CTL DECISION SHEET (DSH)

Standard(s) (incl. year)	Subclause(s)	Tracking No.	Year
IEC 60335-2-29:2002/ AMD1:2004/ AMD2:2009 IEC 60335-2-29:2016	22.26	2126	2019
Category			
HOUS			
Subject	Keywords	Developed by	Approved at
Connection between output circuit and accessible metal parts or earthing terminal	- Connection - Output circuit - Earthing	ETF 1	2019 CTL Plenary Meeting

Fig. 1

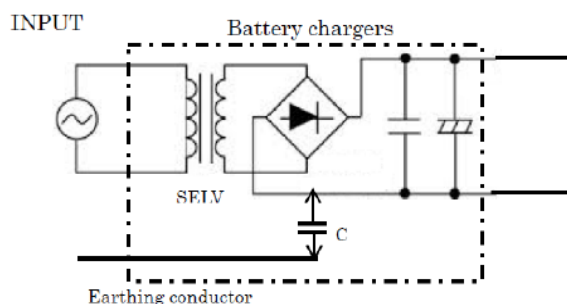
Fig1: Only the output circuit is connected to earth through a capacitor.

If the circuit is connected to earth as described in Fig.1 or Fig.2 by means of a capacitor for functional reason, what is required with respect to the capacitor?

SELV outputs shall not be earthed. As safety extra low voltage can be touched, supplementary insulation is necessary between the output and earth.

Insulation between input or output circuit and earth is, in general, required to be basic insulation for protective earth such that the insulation between the input and output circuit is still double insulation, therefore one of the insulations must meet the requirements for supplementary insulation. If the earth is a functional earth, then Clause 22.53 is applicable.

Fig. 2

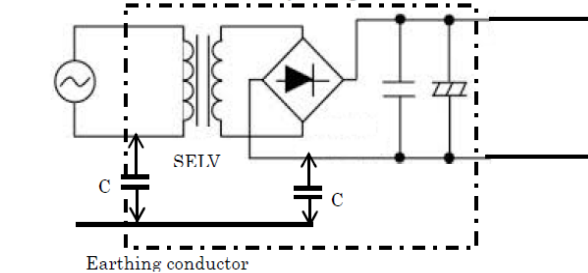
Fig2: Both the input and output circuit are connected to earth through a capacitor.
